IDEA Public Schools Electrical Switchgear Upgrades at Multiple Campuses CSP#22-ESGU-0424

ADDENDUM NO. 3

1. Sheet E2.02:

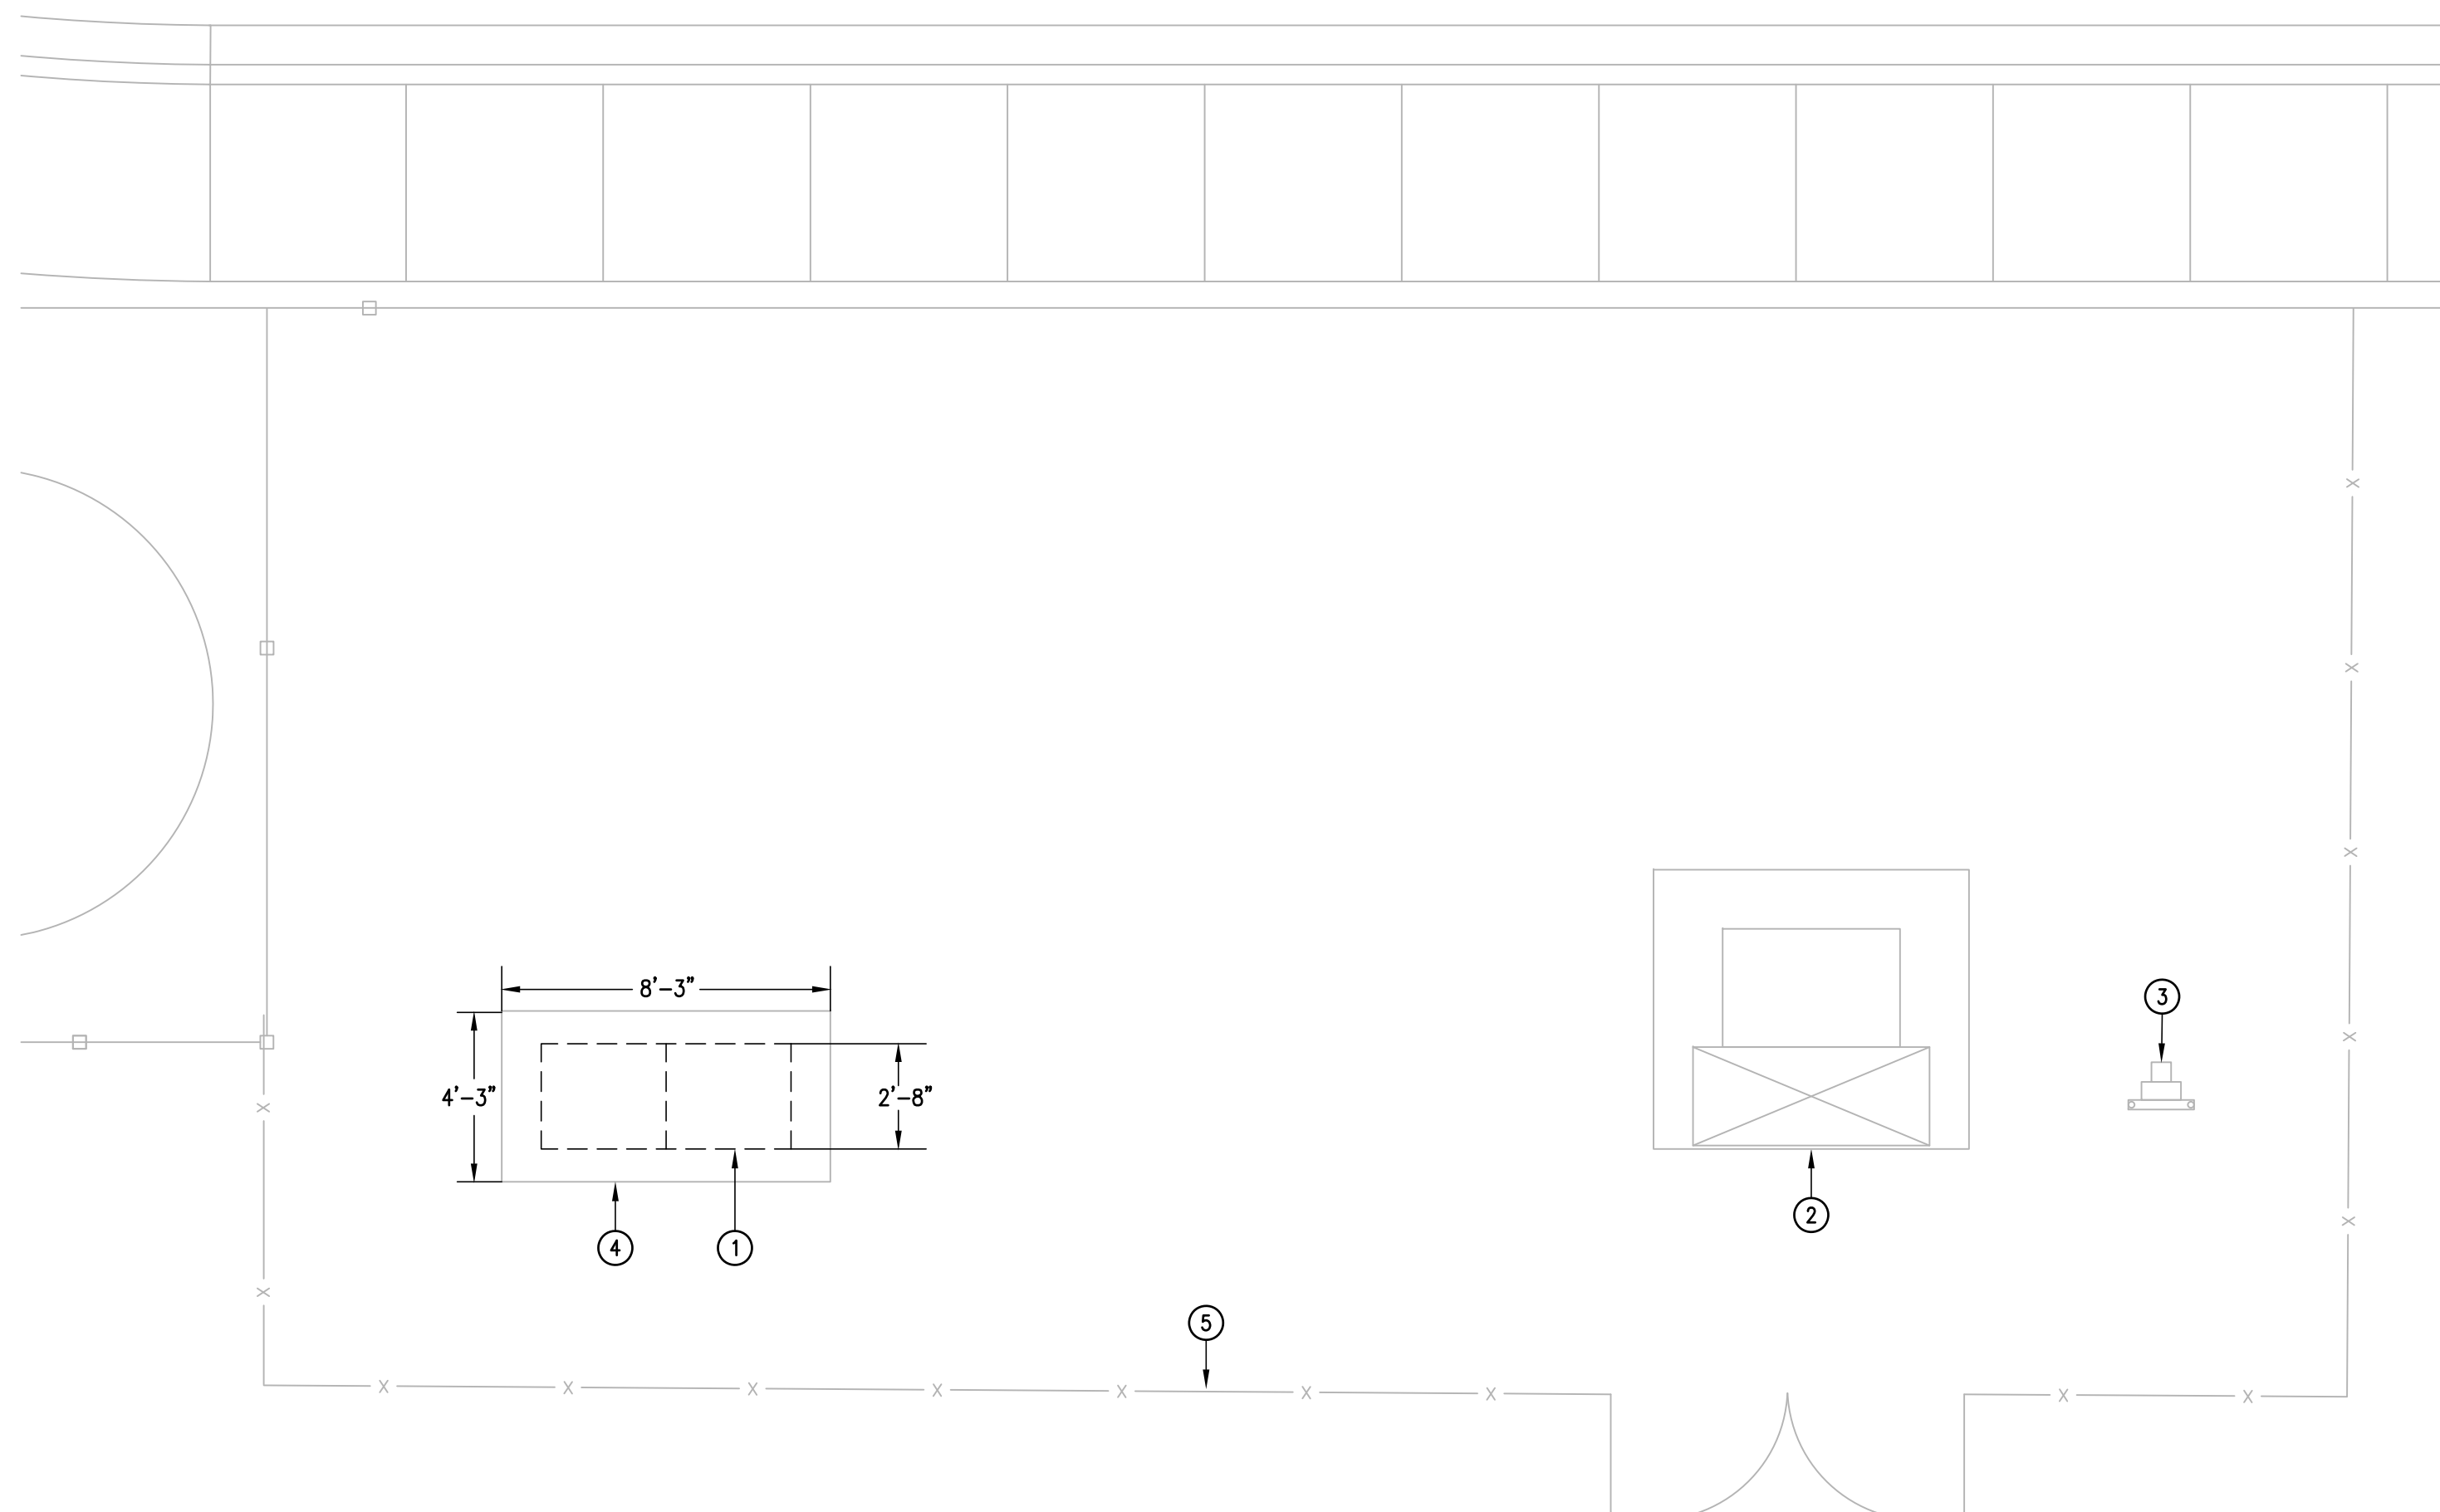
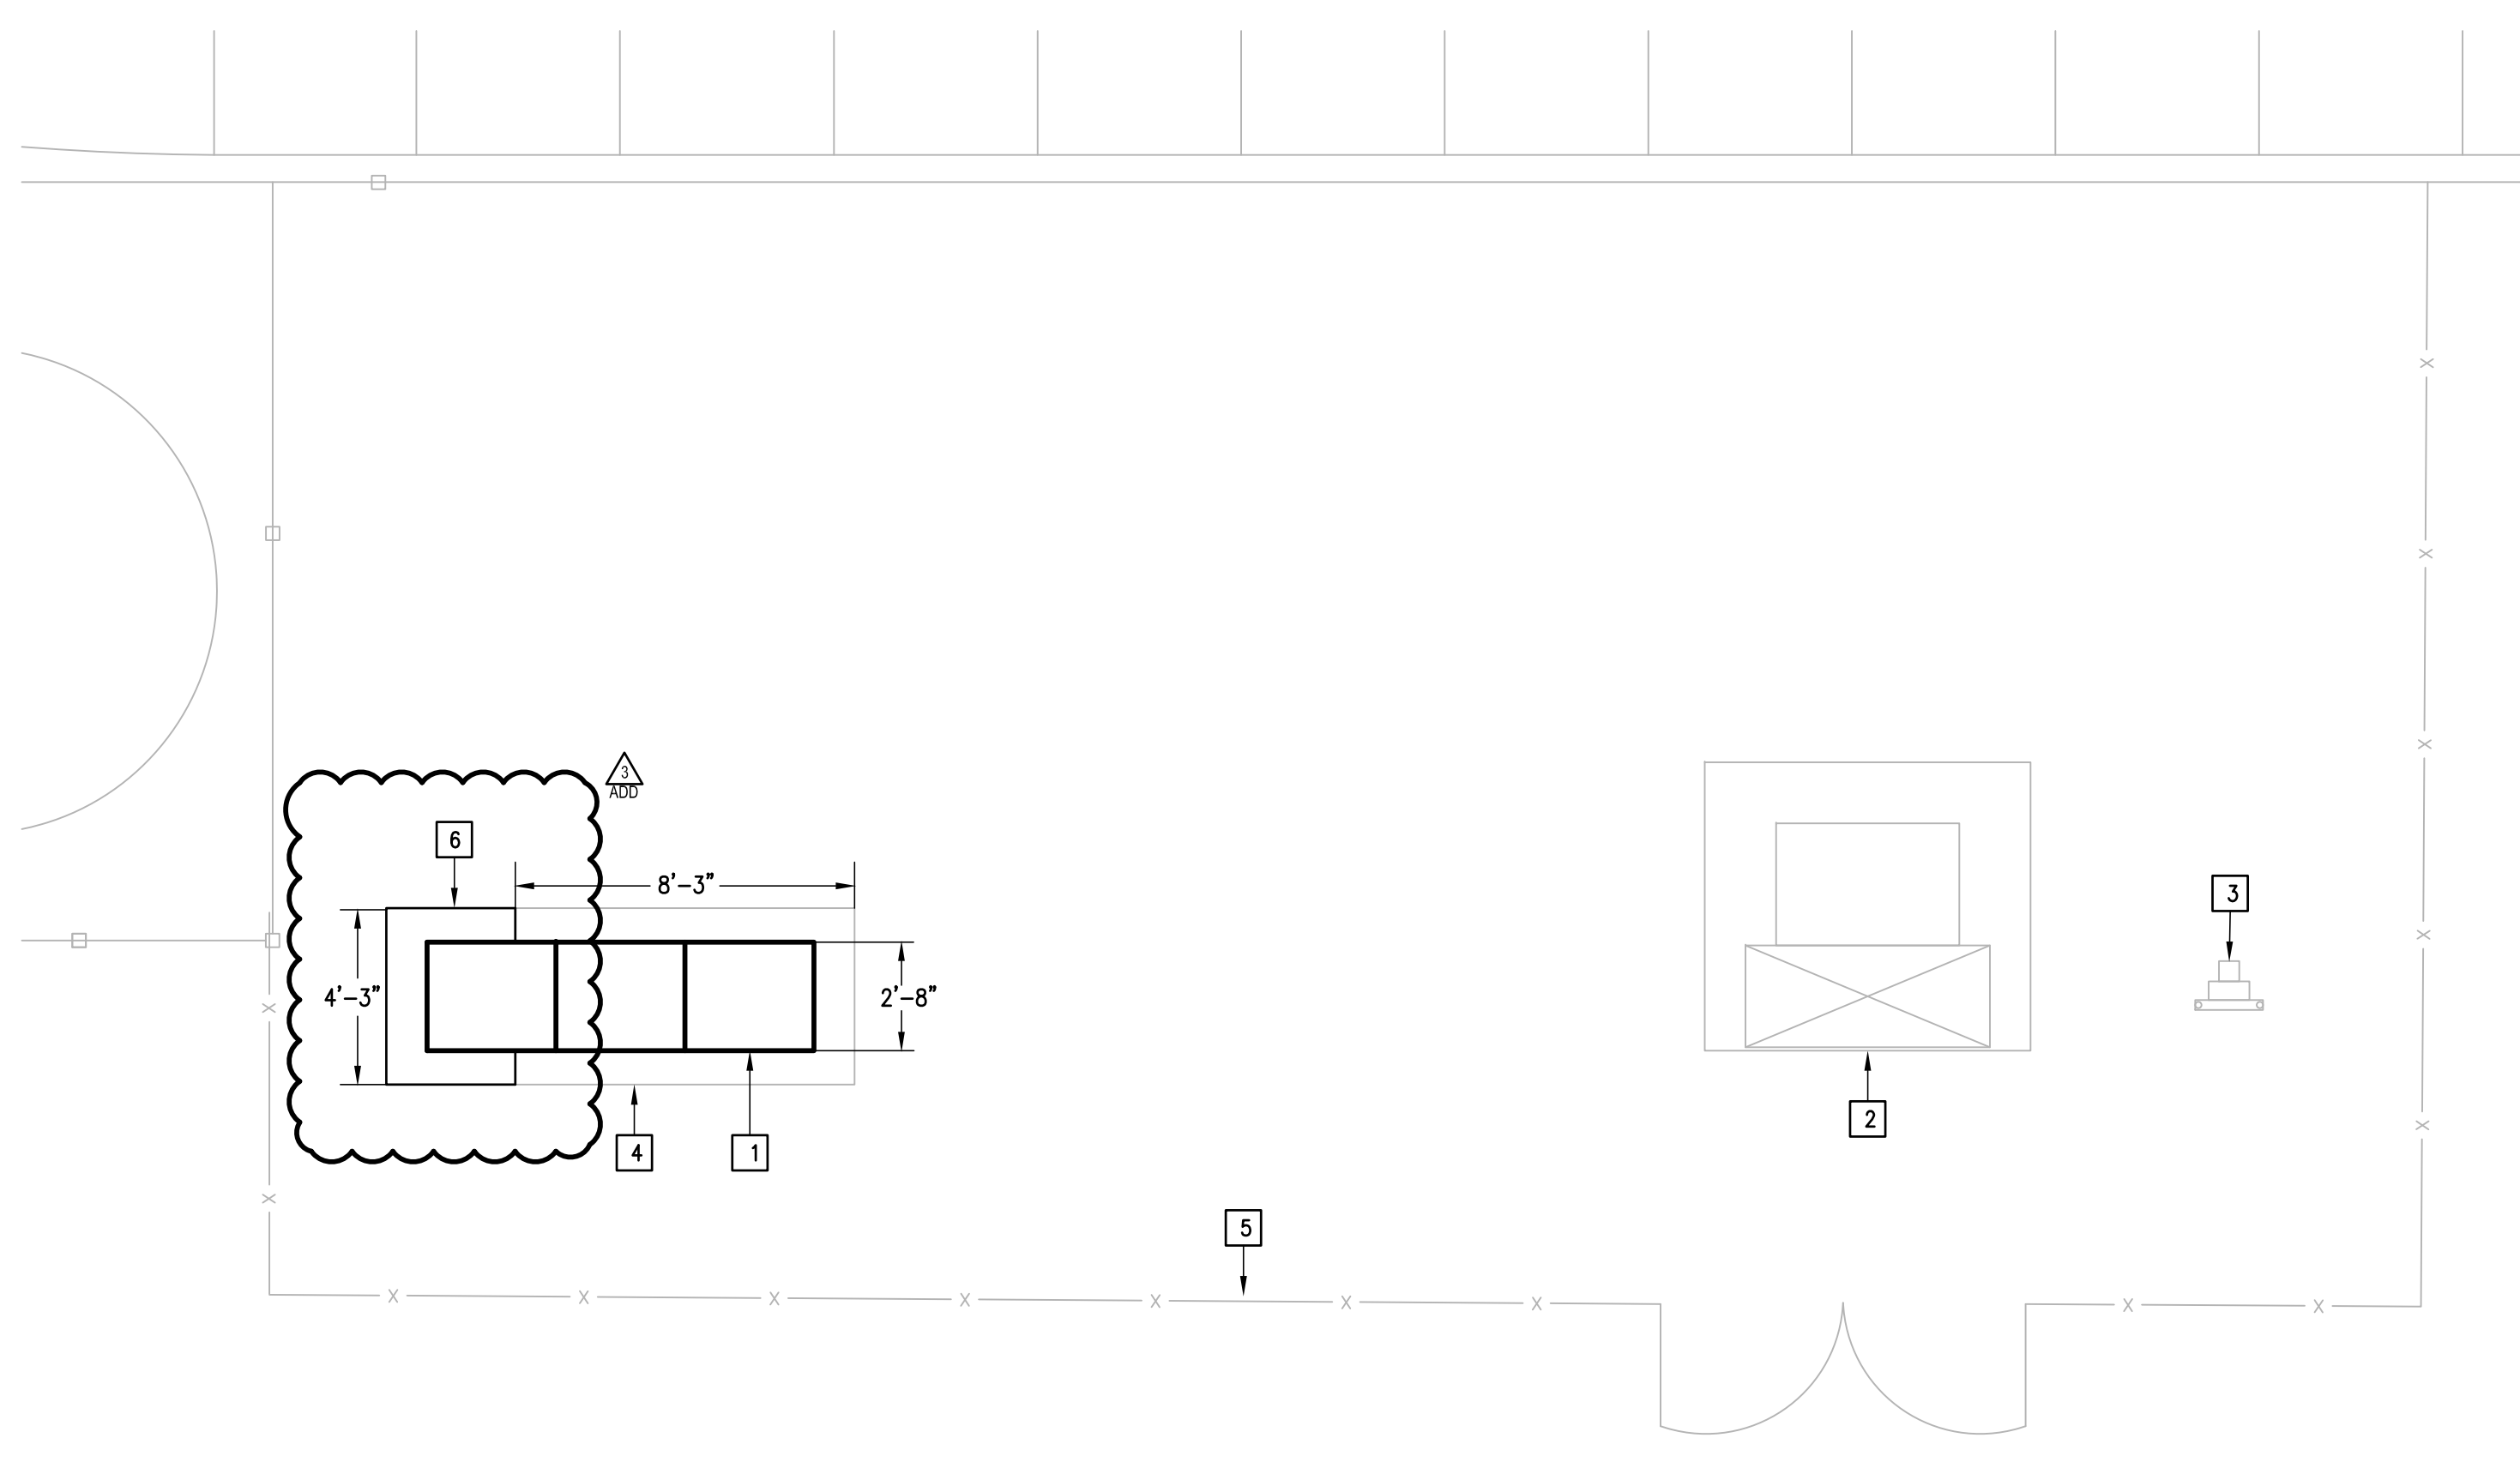
- a) For Edinburg locations, plans required the new switchgear to be MLO service entrance. Please confirm if this complies with the 2020 version of the NEC 230.71 (B) and no need for an MCB for these two locations? **Response: For Edinburg campus see revised plans.**

- a) Revised Plans, Switchboard Elevation and Keyed Notes. See attached sheet.

- NOTES:
1. PROVIDE NEMA 3R OUTDOOR ENCLOSURE.
 2. PROVIDE NEW CIRCUIT BREAKER MUST BE AT OR BELOW EXISTING HEIGHT IN ORDER FOR EXISTING FEEDER TO RECONNECT TO NEW CIRCUIT BREAKER. FIELD VERIFY PRIOR TO ORDERED EQUIPMENT. NO CHANGE ORDERS WILL BE ALLOWED FOR FAILURE TO FIELD VERIFY.
 3. PROVIDE INTEGRAL MOUNTED "SPD".
 4. PROVIDE INTEGRAL MOUNTED MULTI-METER.
 5. PROVIDE A MIMIC BUS.
 6. LABEL EACH BREAKER WITH AN ENGRAVED NAMEPLATE.
 7. PROVIDE SWITCHBOARD SERVICE ENTRANCE RATED.
 8. PROVIDE ARC MITIGATION MEASURES FOR CIRCUIT BREAKERS RATED 1200A AND ABOVE TO COMPLY WITH NEC 240.87.
 9. PROVIDE BRANCH CIRCUIT BREAKERS THERMAL MAGNETIC TYPE.
 10. PROVIDE GROUND-FAULT PROTECTION FOR CIRCUIT BREAKERS RATED 1000A AND ABOVE TO COMPLY WITH NEC 230.95.
 11. PROVIDE SWITCHBOARD TO COMPLY WITH 2020 NEC 230.71(B).
